Stormwater Quality Plan Information Sheet and Inspection Fee Schedule

Project Name: Coors & Western Trail Tract 3A

**RE: RESPONSE TO STORMWATER QUALITY COMMENTS
ATIVO ALBUQUERQUE LLC – 4500 QUAKER HEIGHTS
EROSION AND SEDIMENT CONTROL PLAN**

\\TWA\S\Z_Drive\2019\064 Coors Village Tract 3A.dwg,AA\2019064_SWPPP.dwg May 18, 2021 - 7:45am

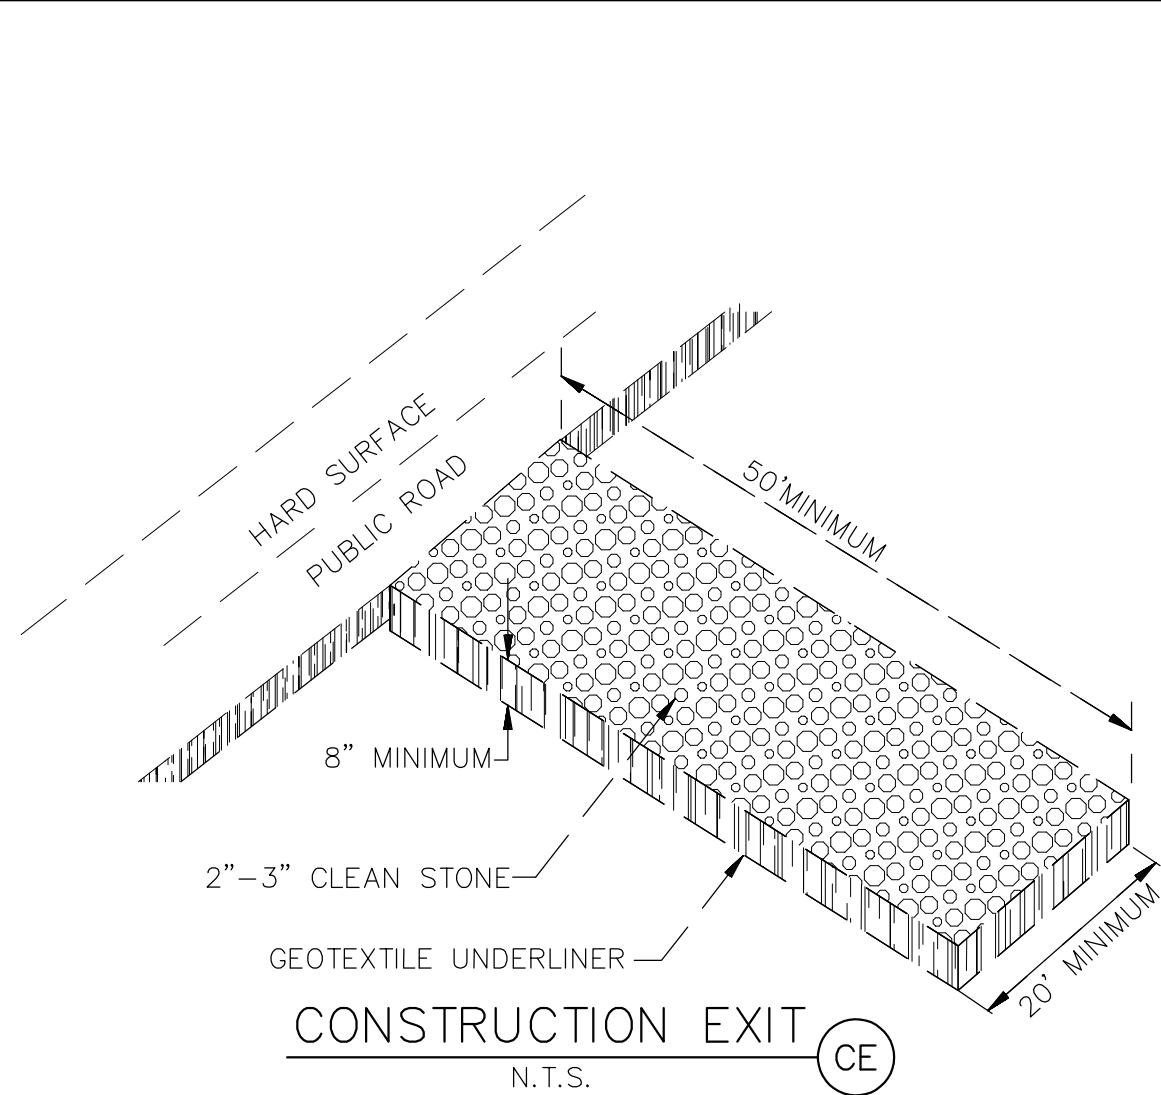
1. The "limits of disturbance" symbol in the legend is not shown anywhere on the plan. Clearly indicate the limits of disturbance. (CGP7.2.4.b.i)
Response: The limits of disturbance are now shown on the plan with line work matching that of the legend.

Response: The site plan is being included in this ESC Plan resubmittal package.
3. Describe undisturbed and pre-construction ground cover (CGP7.2.4.e)
Response: A "Undisturbed and Pre-Construction Ground Cover" note has been added to the plan for describing existing ground cover.

4. List operators on the plan, including name, phone #, and e-mail address. Include the developer/property owner's representative authorized to make changes to contract documents, plans, and specifications per CGP 7.2.1. If there are multiple operators describe the area of control for each. State whether the operators will share a SWPPP or if they will each have separate SWPPPs

Response: The operators (the owner and contractor) are now listed on the plan with contact information.
5. Identify stormwater team members responsible for sediment removal, BMP maintenance, and inspections on the plan, including name, phone #, and e-mail address (CGP 7.2.2). Provide the stormwater team for each operator

Response: A stormwater team members list has been added to the plan with contact information.
6. Describe the nature and extent of construction activities for each operator (CGP7.2.2.), including a) nature of construction activities, b) size of the property, c) size of disturbed area, d) description of construction support activities, and e) size of maximum disturbed area.

8. Soil information – add a table with name type, particle sizes, and Erodibility factor (CGP 2.1.1).

10. City Standard ESC Notes attached.

Response: This information has been added to the plan.

Response: A soil information sheet has been added to the plan for providing this information.

Response: These notes have been added to the plan.

TRACT 3A COORS VILLAGE 4500 QUAKER HEIGHTS AVE NM 87120	DRAWN BY RS
	SITE PLAN FOR BUILDING PERMIT	DATE 6/24/2020
		2019064_SP
		SHEET # C1

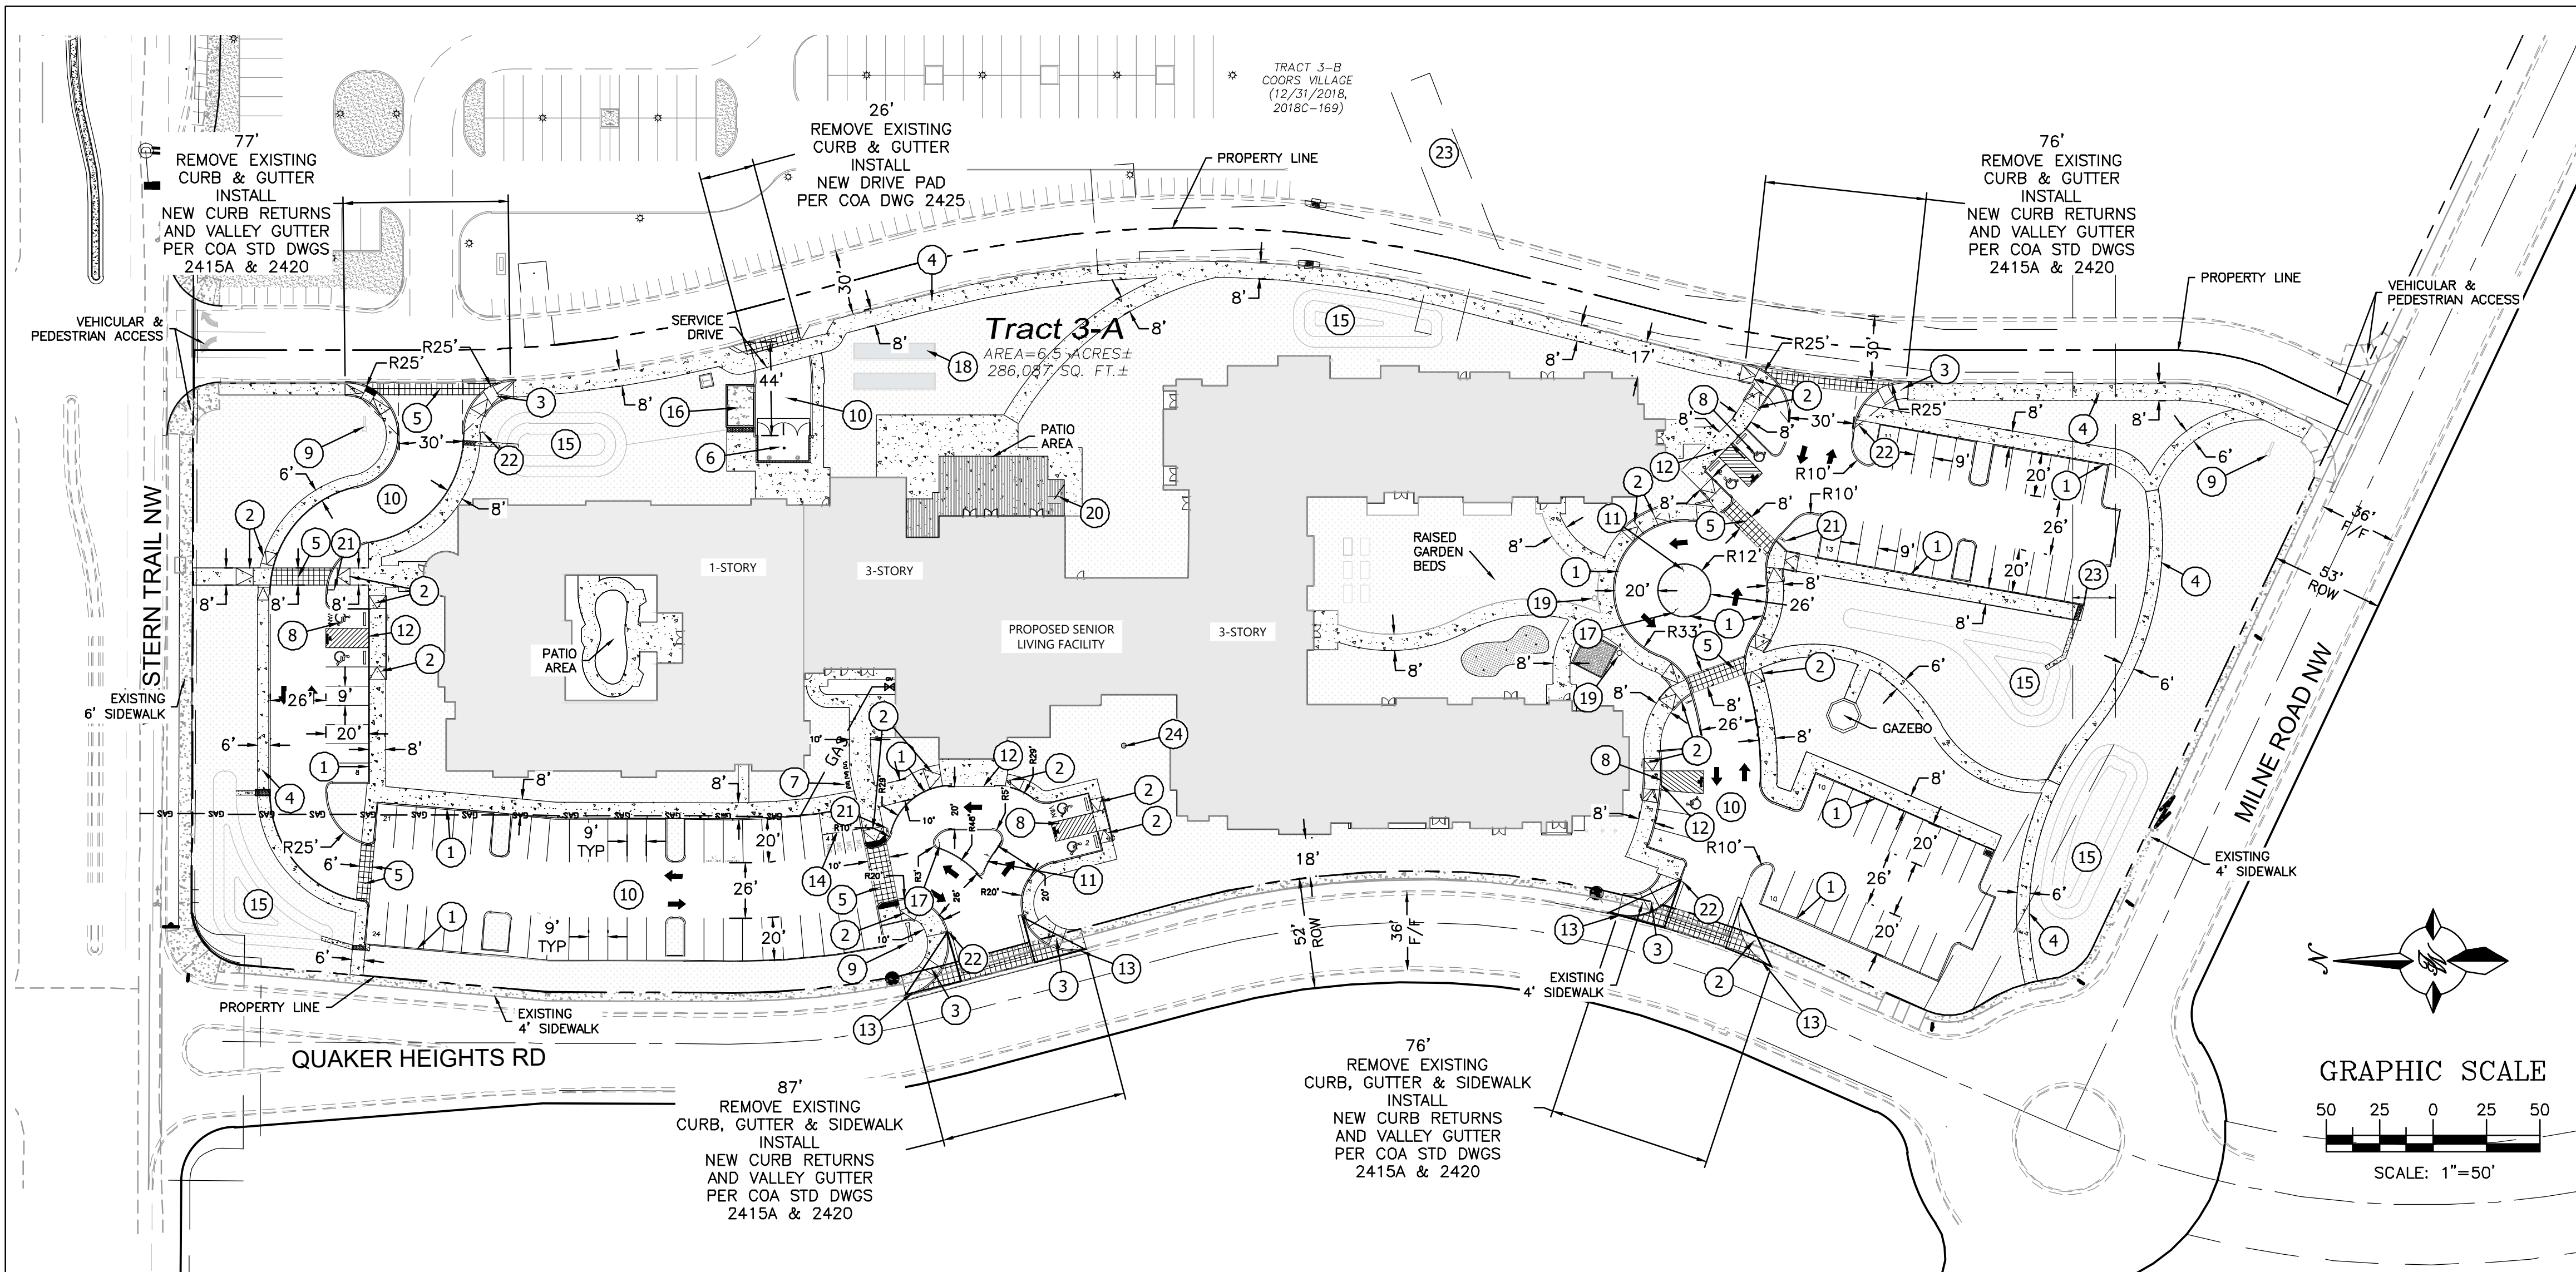
2. The locations of structures and other impervious surfaces. (CGP7.2.4.b.v). The Site Plan can be used to satisfy this requirement and should be included in the SWPPP and the ESC Plan submittal.

OVERALL
PLAN

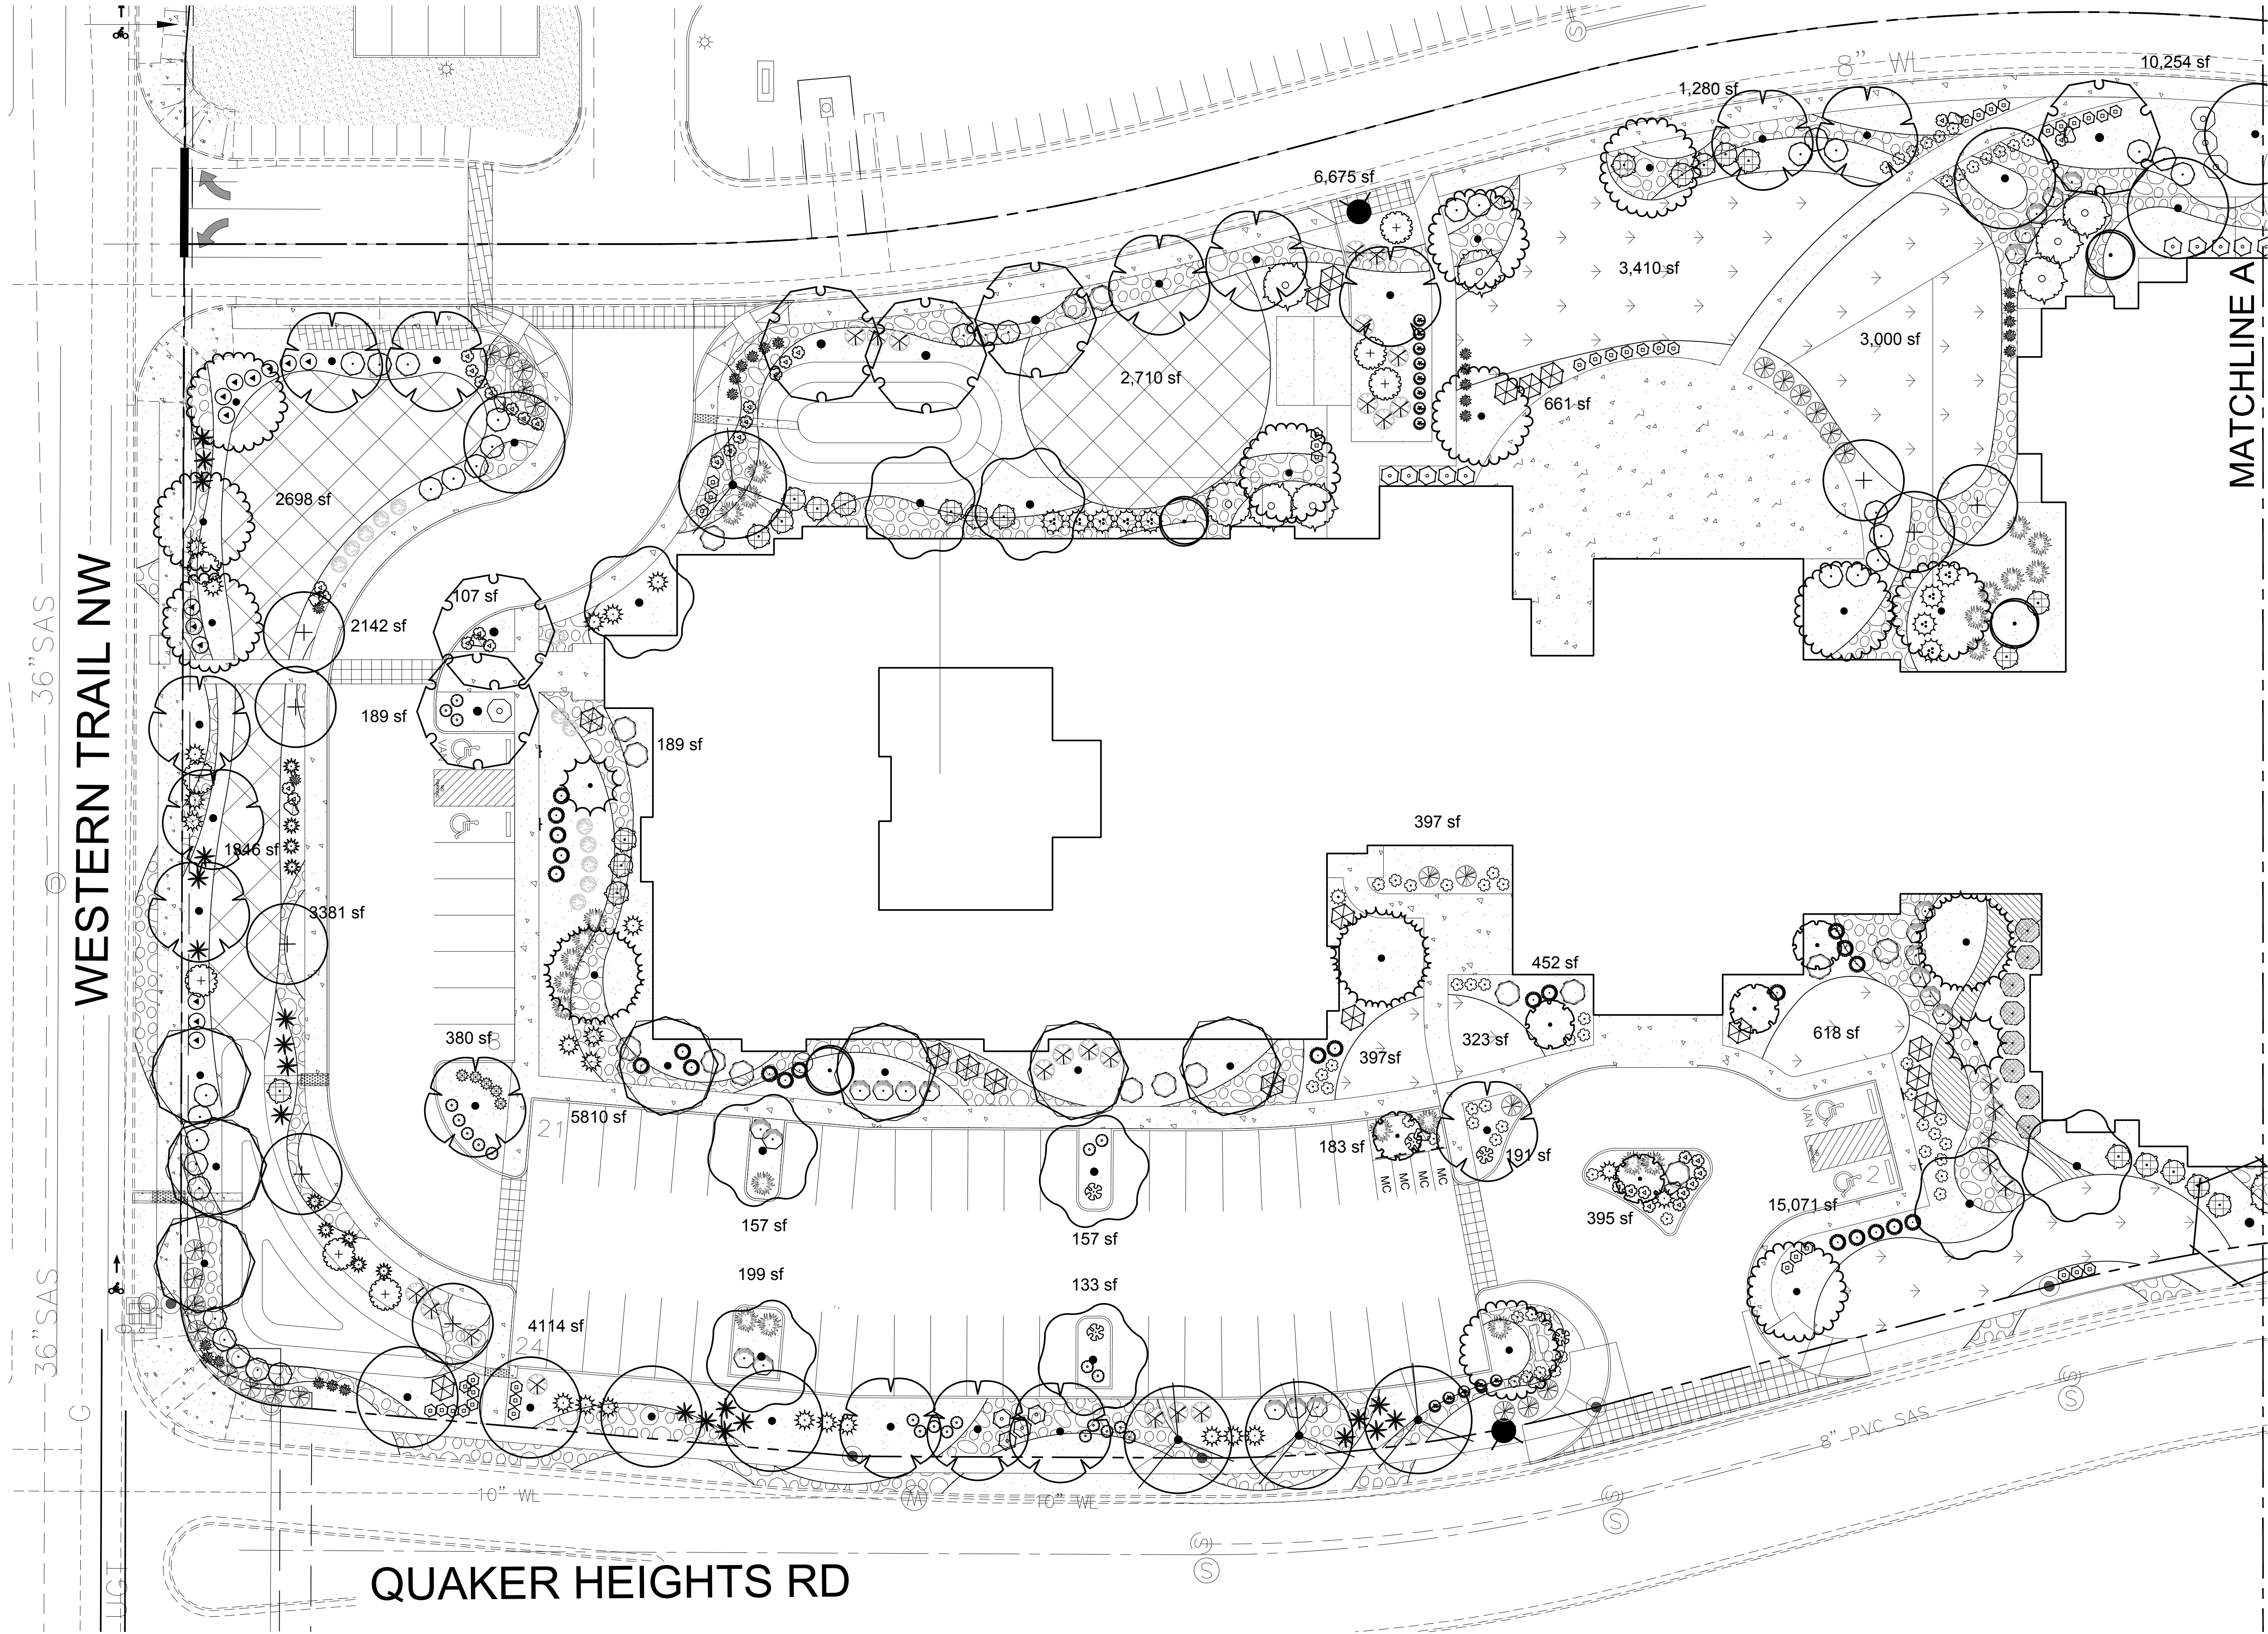
7. Stabilization measures (CGP 7.2.6.b.vi), including a) Specific vegetative and nonvegetative practices, b) deadlines, c) beginning and ending dates of the seasonably dry period, d) procedure to comply with The Weed Removal Ordinance (§ 9-8-1). The landscape plan can be used to satisfy this requirement and should be included in the SWPPP and the ESC Plan submittal. It should include the street right of way adjacent to the site.

Response: The landscape plan is being provided with this ESC Plan resubmittal to satisfy this requirement.
